**ADDENDUM NO. 1
for the
La Granada Pump Station Project
Specification No. 2018/19-25
Project No. CI 8082**

LA GRANADA PUMP STATION
PLC CONTROL PANEL - DC POWER DISTRIBUTION

SHEET 71 OF 89

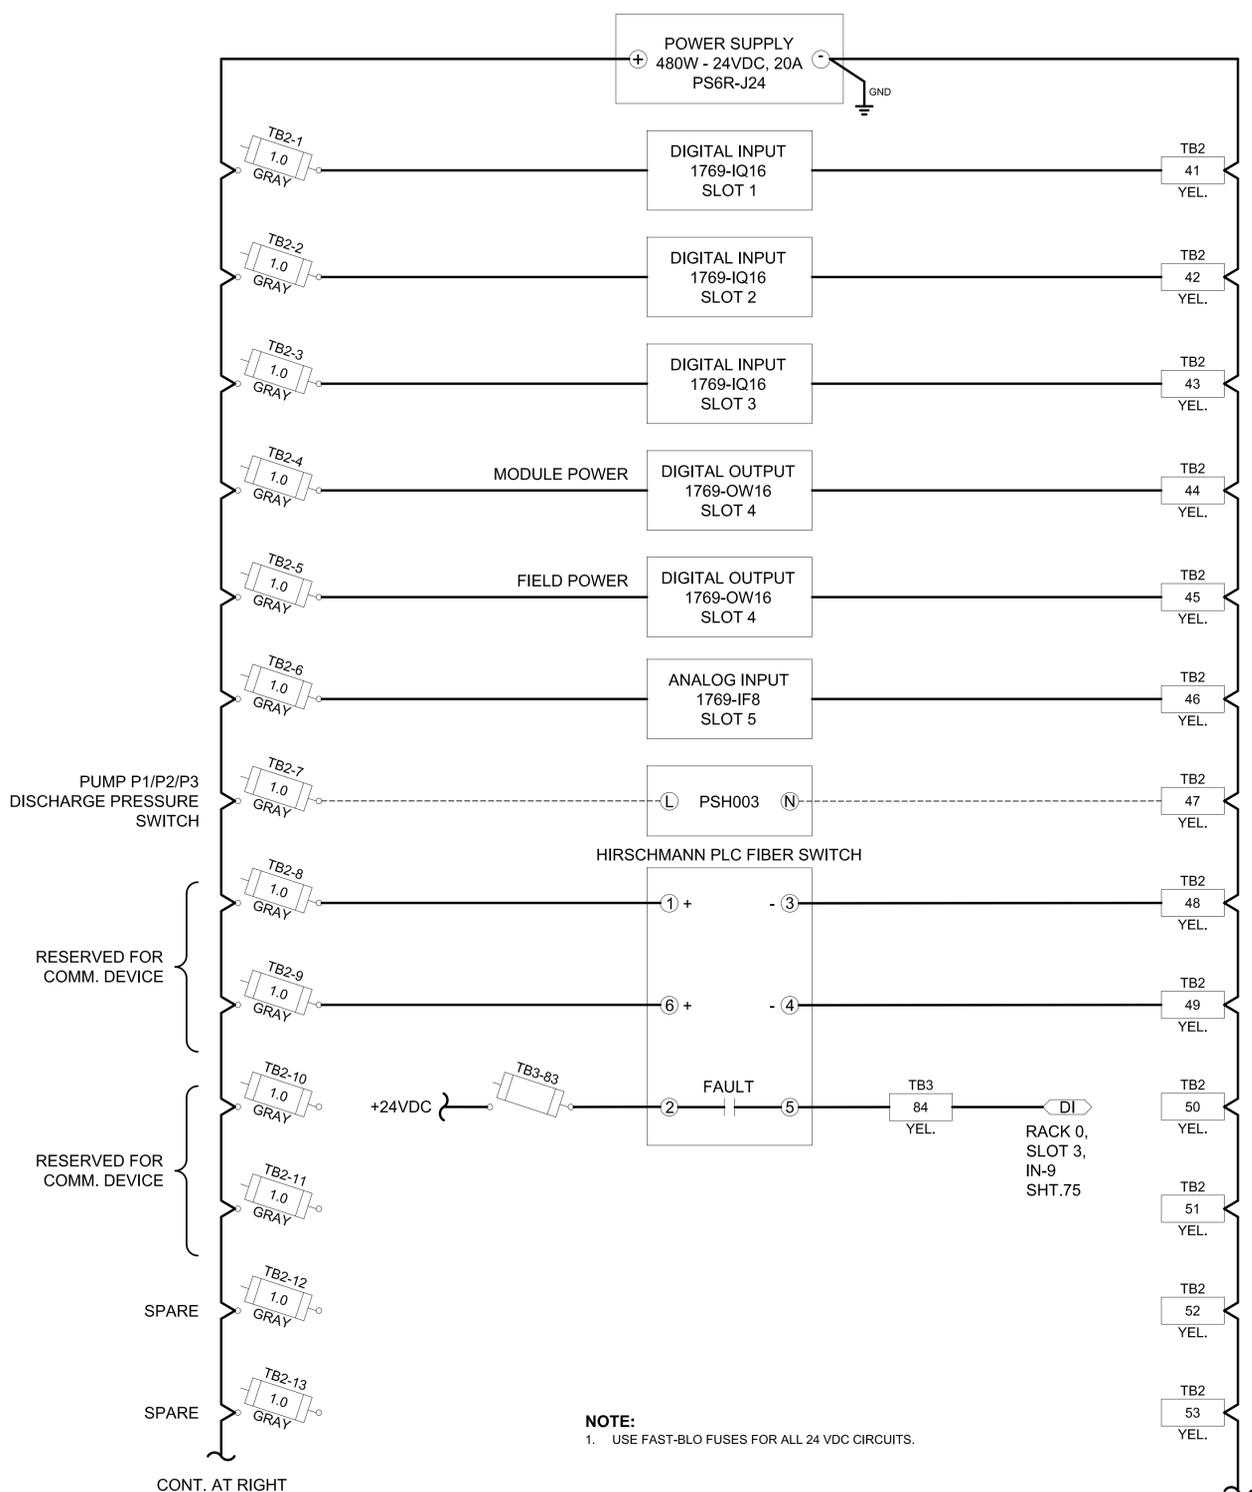
- Item 1:** Replace Plan Sheet 71 of 89 with the revised Plan Sheet 71 of 89 as attached Exhibit "A"
- Item 2:** Replace Plan Sheet 72 of 89 with the revised Plan Sheet 72 of 89 as attached Exhibit "B"
- Item 3:** Add a new Specification Section 16 25 00, Lighting System as attached Exhibit C
- Item 4:** Add a new Specification Section 16 30 00, Underground System as attached Exhibit D
- Item 5:** Section 01 52 00, Engineer's Field Office, Equipment and Services:

REV	SYMBOL	DESCRIPTION OF CHANGE	R.C.E.	DATE	C.T.O.	DATE	CHECKED
1	▲	PUMP DISCHARGE PRESS. SWITCH POSITION CHANGE FOR ADDENDUM NO. 1	AMS	3/3/20	SS	3/3/20	QAY

CITY OF THOUSAND OAKS
LA GRANADA PUMP STATION
PLC CONTROL PANEL - DC POWER DISTRIBUTION (CONT.)
CITY OF THOUSAND OAKS DWG. 15-04A
SHEET 72 OF 89

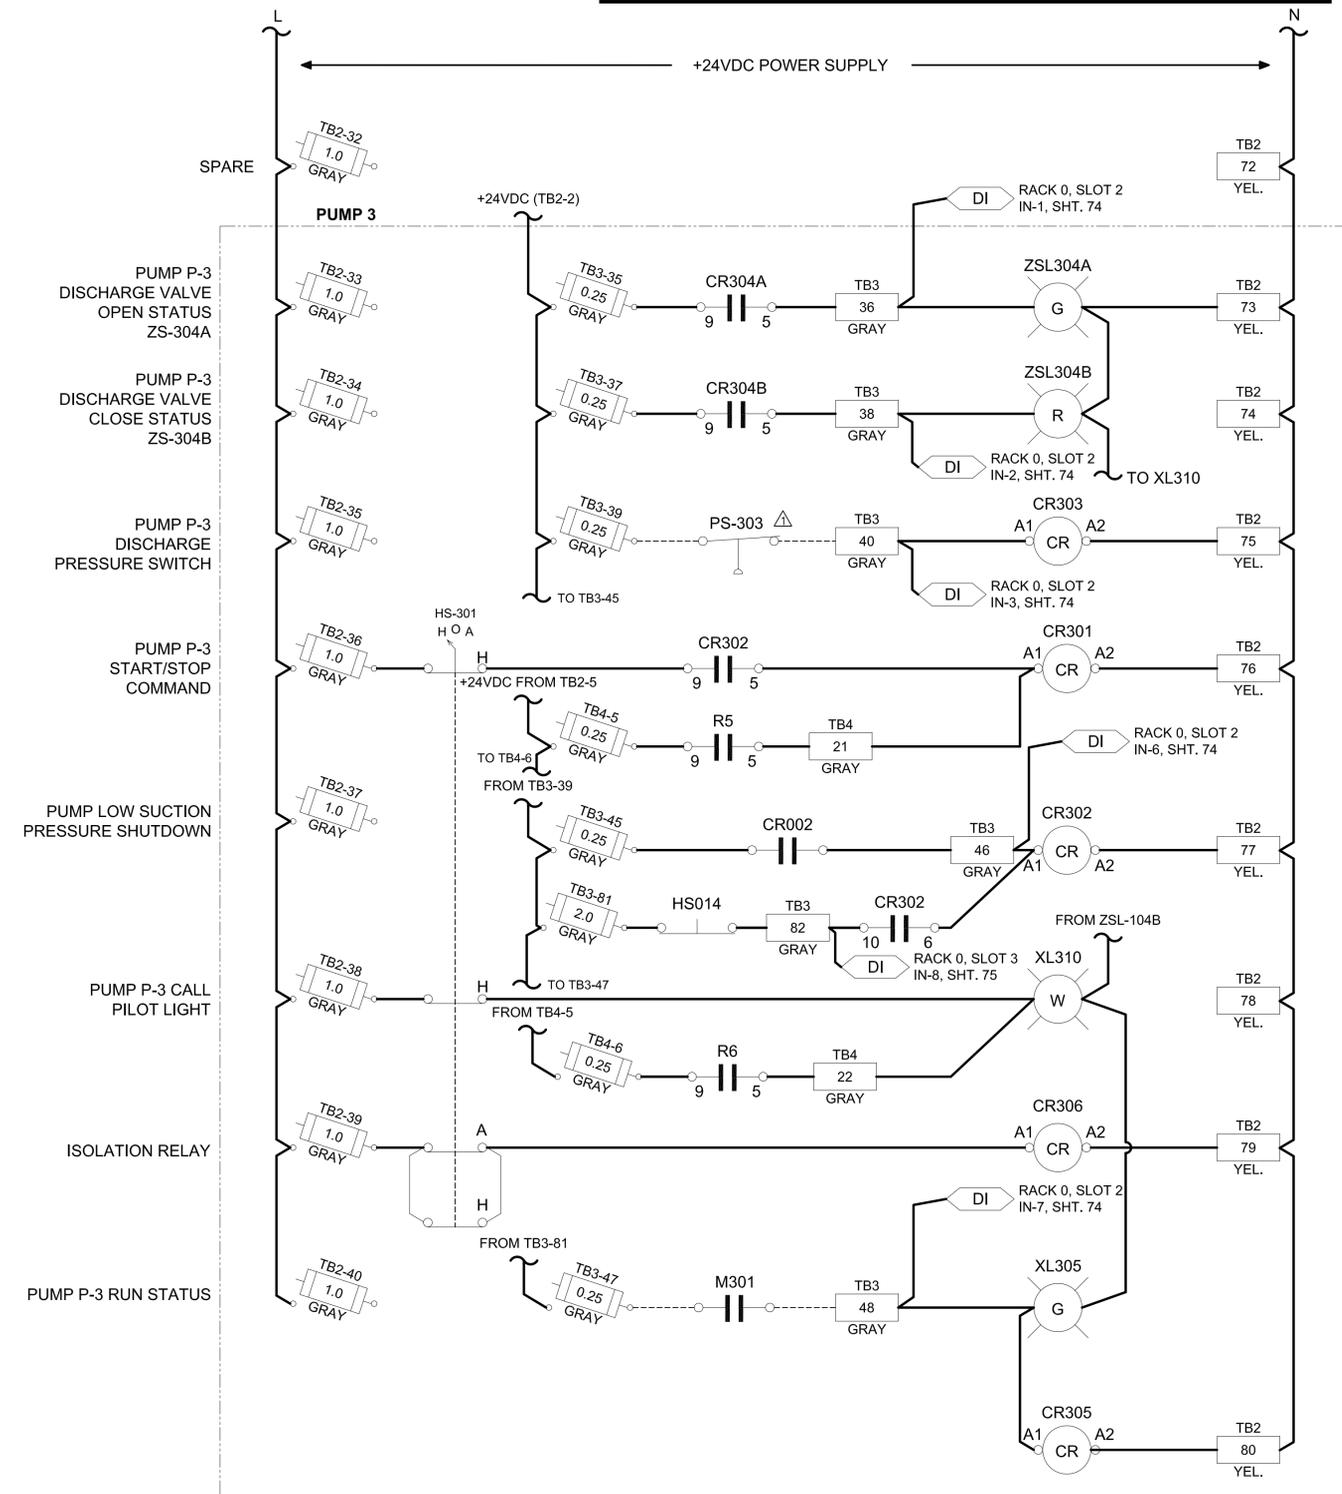
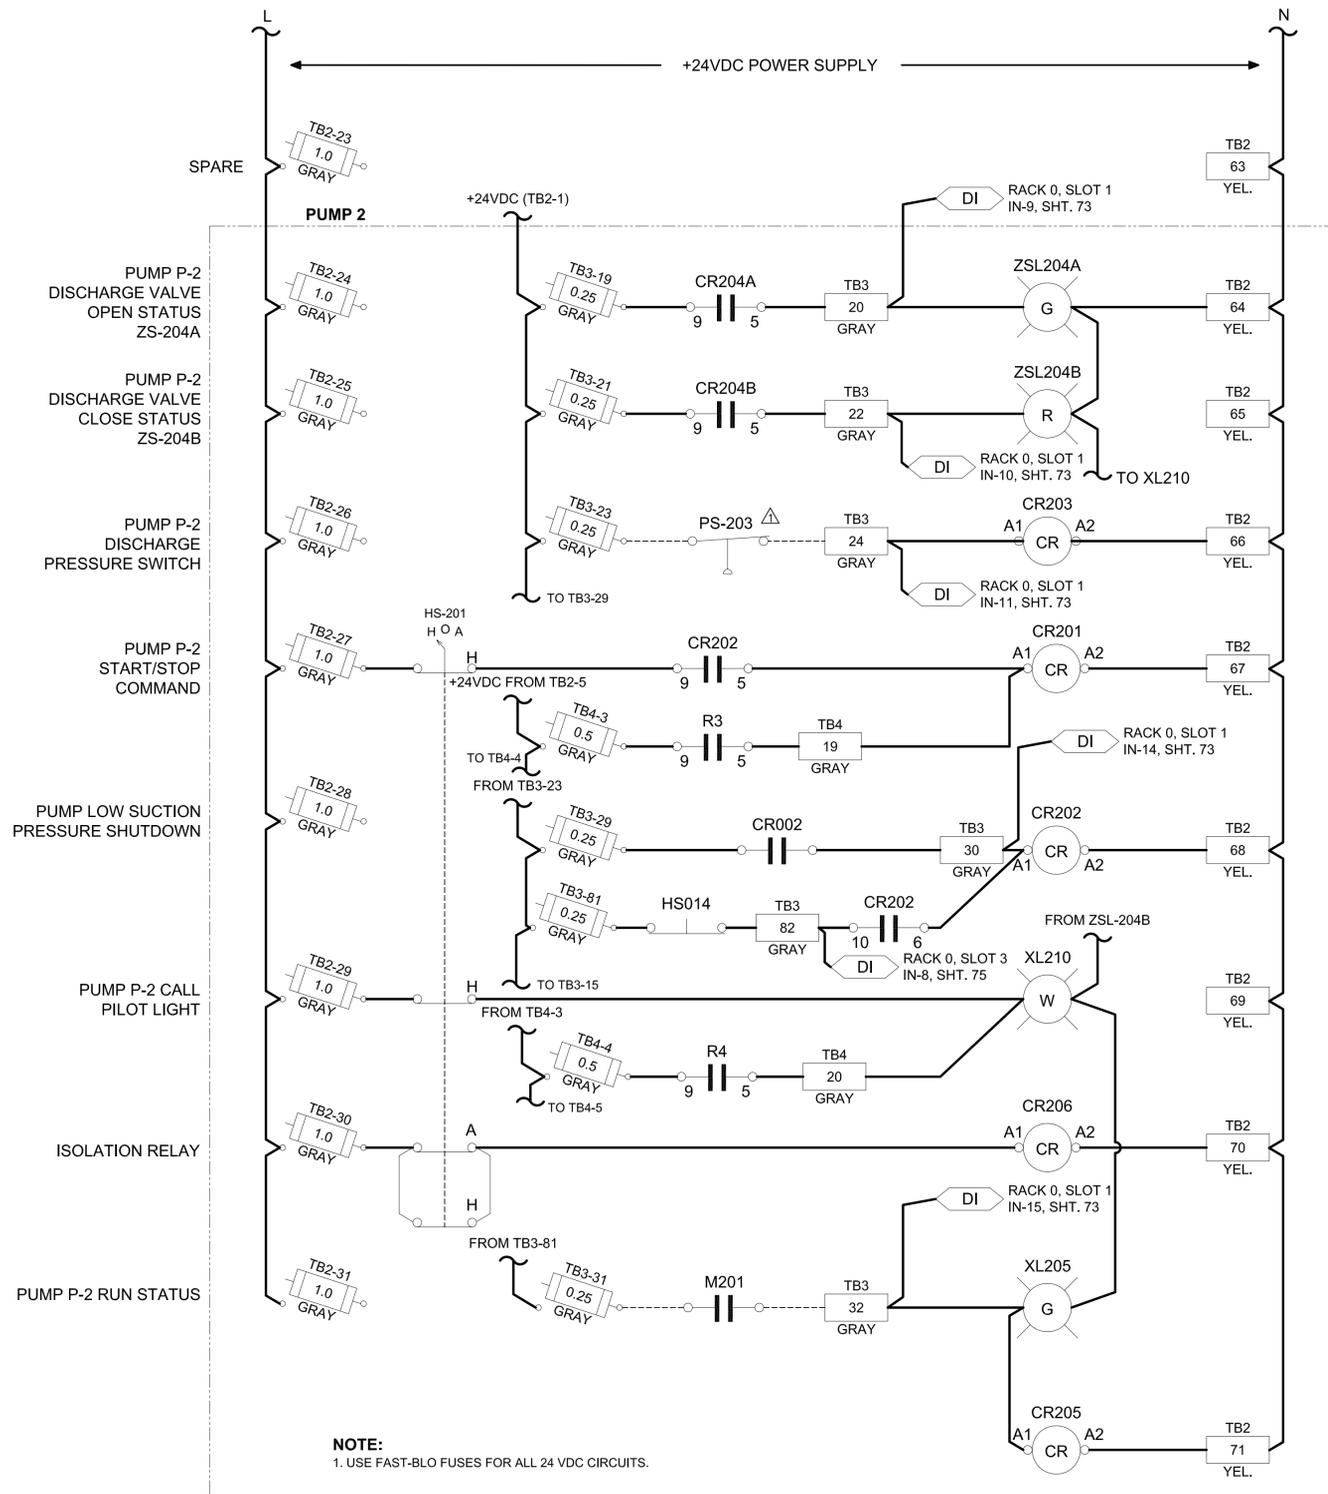
REV	SYMBOL	DESCRIPTION OF CHANGE	AMS	DATE	SS	DATE	QAY	DATE	CHECKED
1	▲	PUMP DISCHARGE PRESS. SWITCH POSITION CHANGE FOR ADDENDUM NO. 1	AMS	3/3/20	SS	3/3/20
